Subject: Planning Application P210105/F

Planning Application - P210105/F - Objection

Appendix A

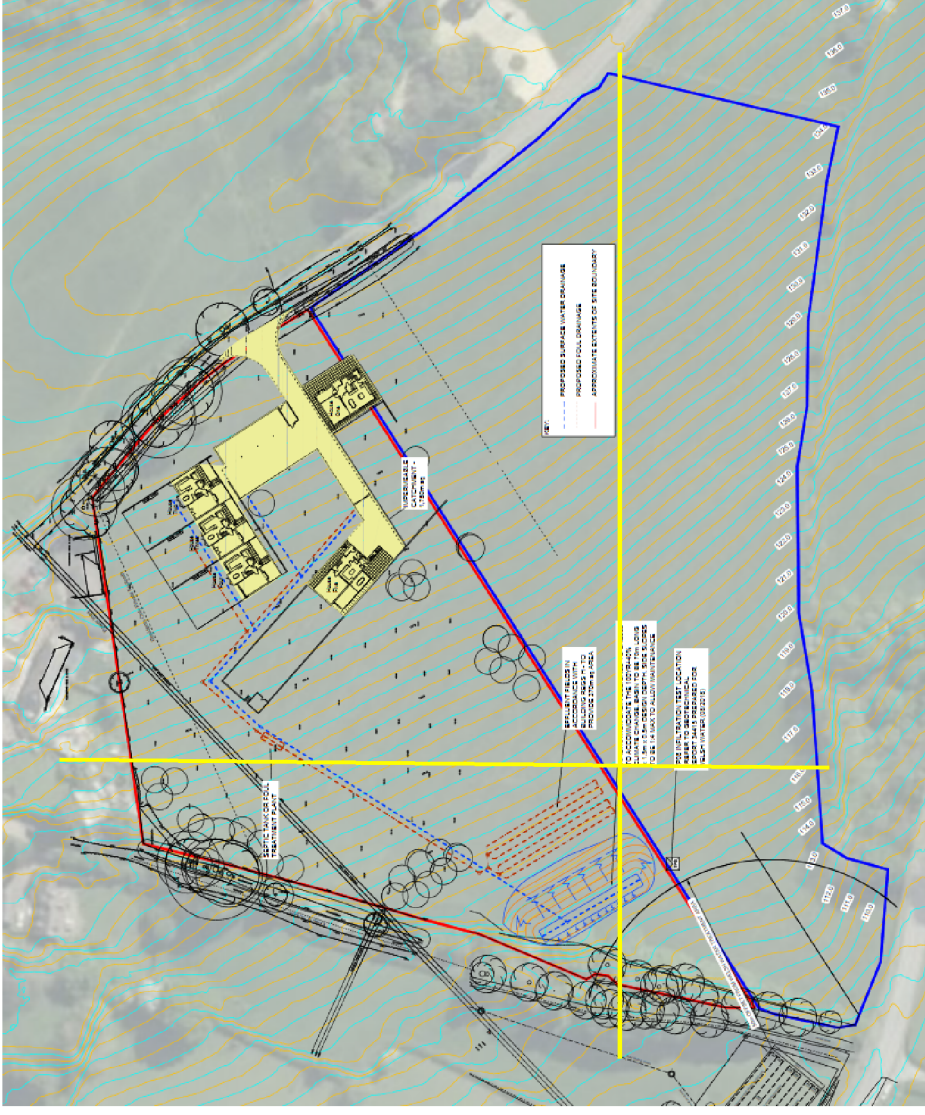
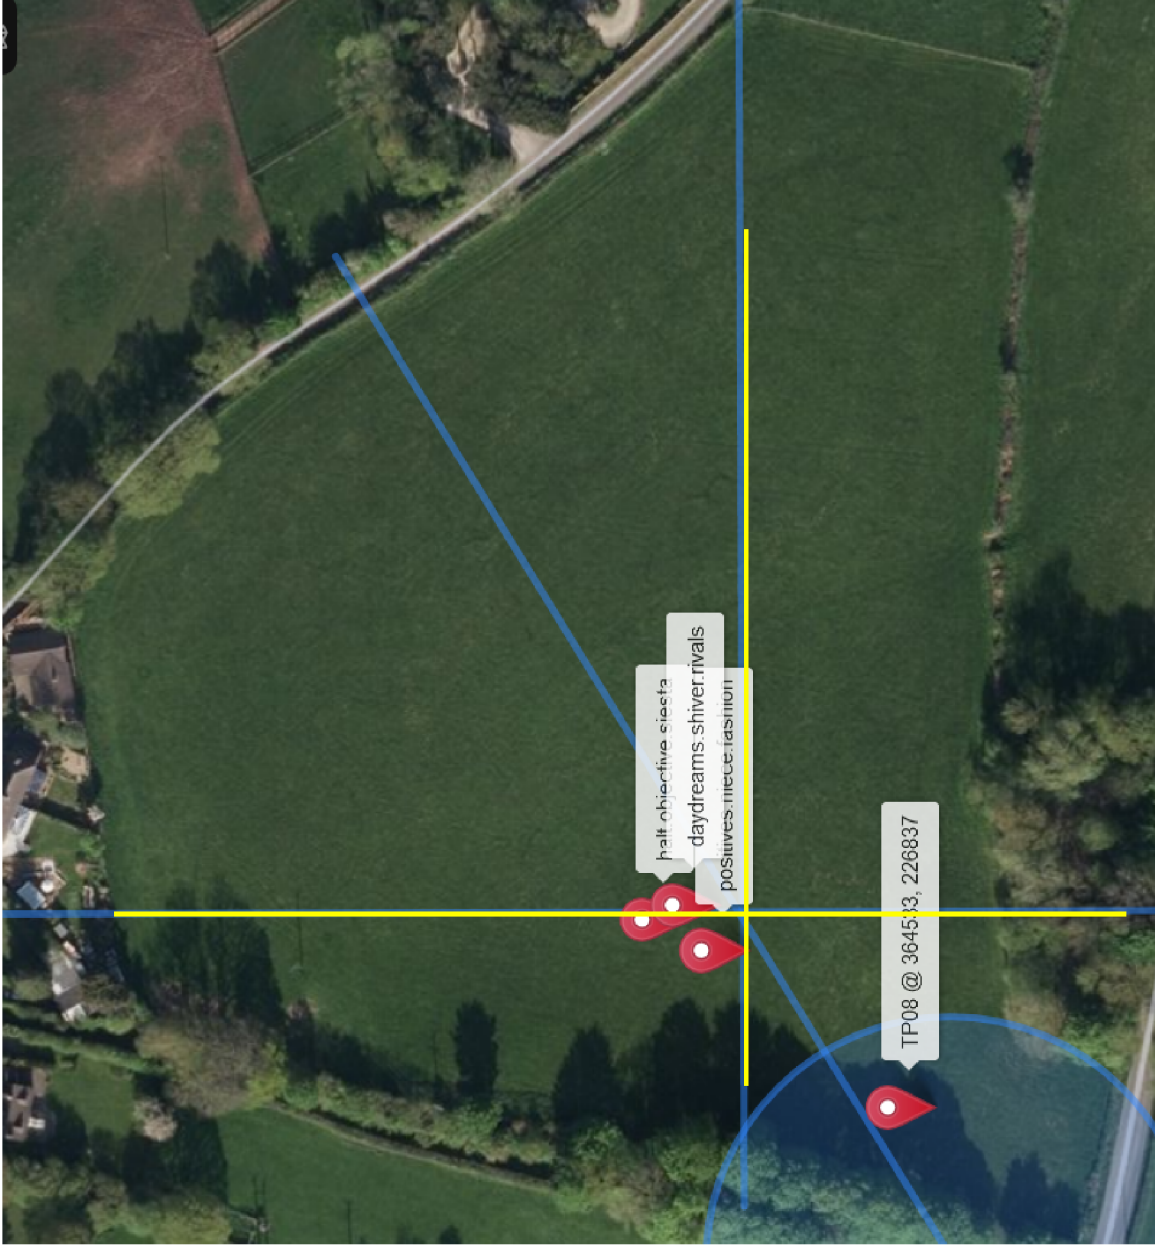
an argument for not conducting more percolation tests on site. TP08 is shown as located along contour line 115.5m. The infiltration basin runs along contour 115.5m yet the effluent field is situated higher up between contours 118m - 120m, so on that same argument TP08 results are irrelevant at the higher level. Therefore it should be argued that percolation testing should be done separately for the infiltration basin and effluent field as they are at completely different levels on the hillside. The ground profile within this field is relatively steep and to create any new drainage field on this land would require significant ground reprofiling to facilitate any new drainage field construction.

The effluent field and infiltration basin are both positioned running in a line SSE, NNW from a southerly starting position north of TP08, no infiltration testing has yet been done on the northern end of the drainage facility to prove its viability despite repeated requests by BBLP (10:51;11:02;13:03 30/10/20).

In Appendix A the left hand map shows the Test Locations conducted by CTP 13:39 23/10/20. Using fixed points I have used horizontal and vertical lines to target the Test Locations with the resulting cross hairs being slightly off target the horizontal line being slightly down (south) and the vertical line being right (east) but providing a reasonable point for comparison.

The right hand map/plan/image is taken from Drainage Strategy report, I have added the cross hairs using the same fixed points for reference. The crossed hairs allows comparison of proposed drainage feature locations.
